Bulletin No.: PI1142

Service Bulletin

Subject: Front Floor Console Extension Side Panel Change

Models: 2014 Chevrolet Impala
Vehicles Built Prior to November 1, 2013

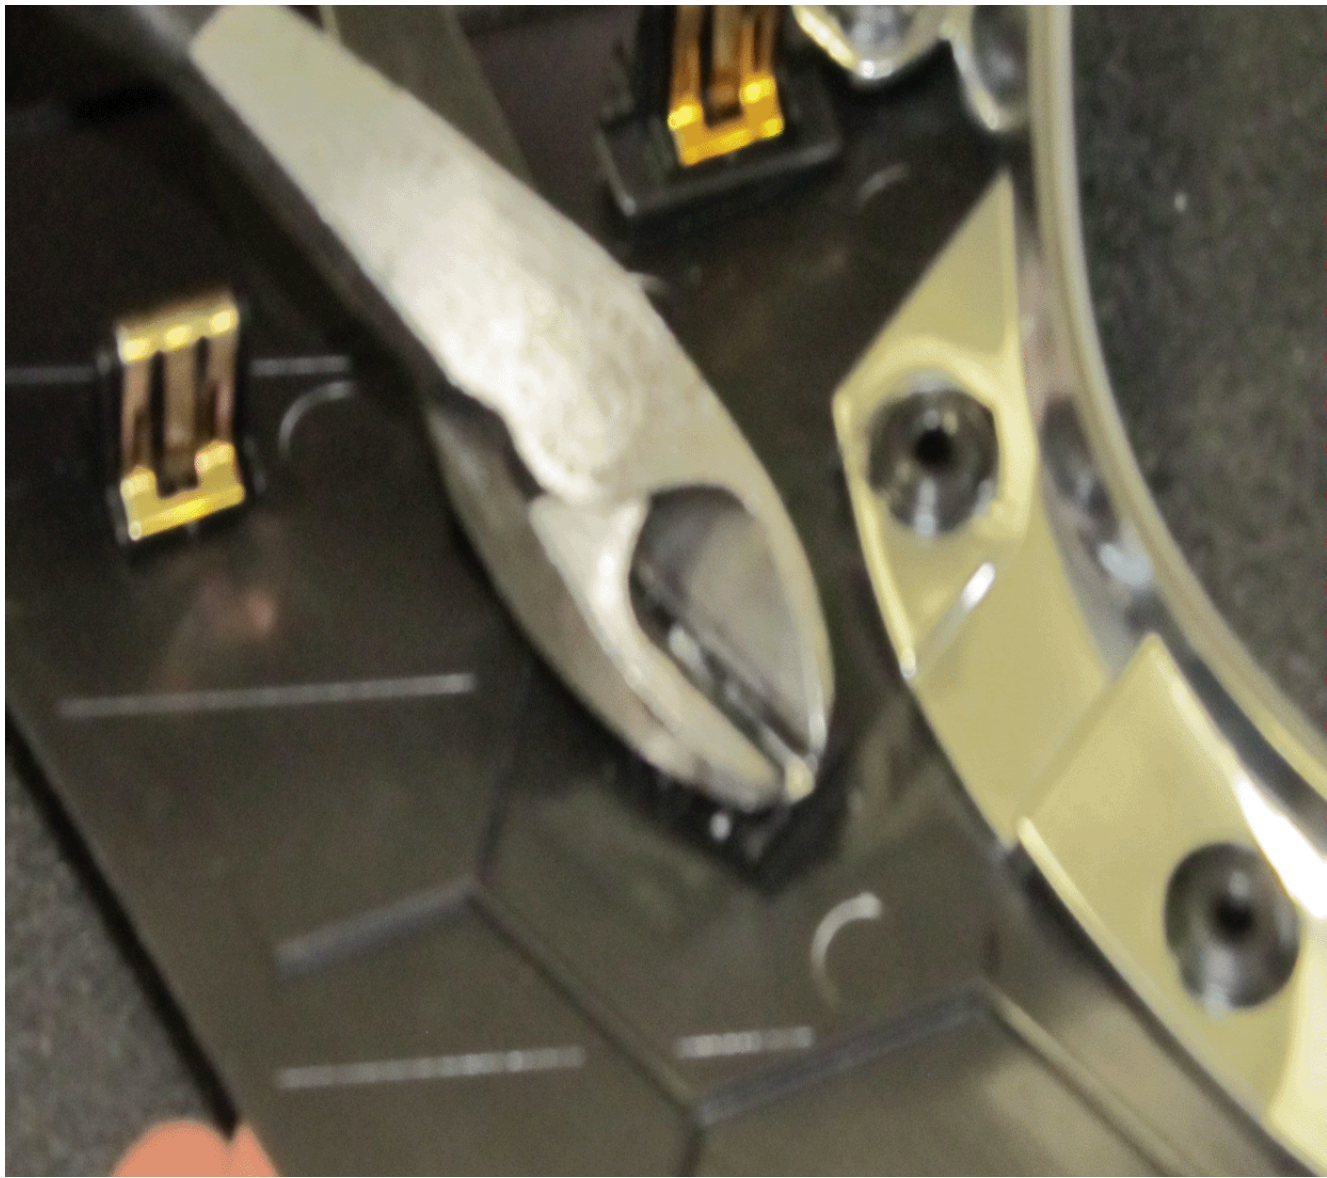
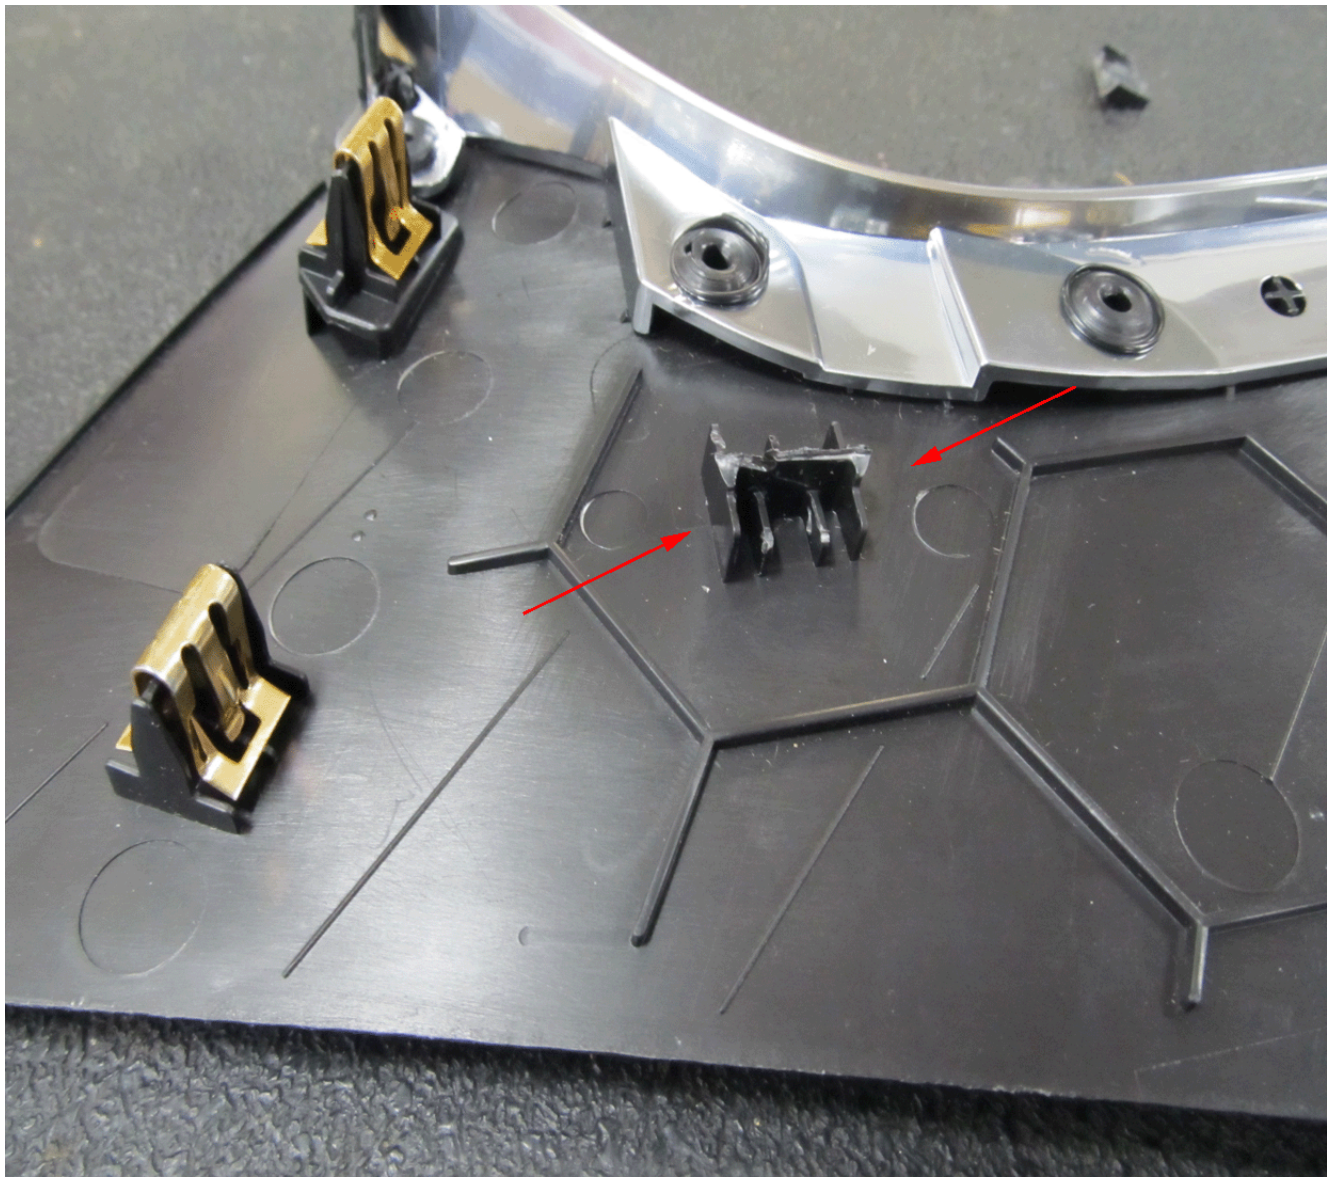
The purpose of this PI is to inform the technician that when replacing the front floor console extension side panels, the new panels come with an additional clip tower, shown in the illustration above, that needs to be modified for vehicles built prior to the date listed above.

Cut the clip tower using a pair of wire cutters as shown in the illustration above.
